ADDENDUM NO. 2

PROJECT: Edgewater Art House
The Resource Center
Jamestown, New York

LABELLA PROJECT NO.: 2192683.01

DATE: August 27, 2021

1 PLAN @ CASEWORK
A1 OF 2 SCALE: 1/4" = 1'-0"

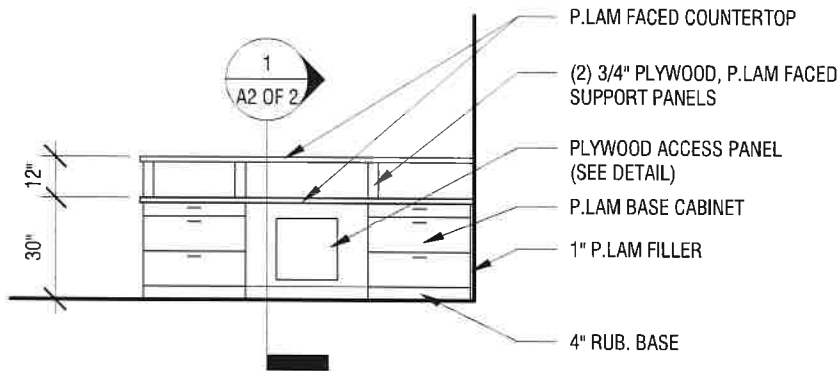
A. Floor Plan Key Note A4 references the new reception desk. Refer to attached casework sketches A1 of 2 and A2 of 2 in this Addendum for more information.
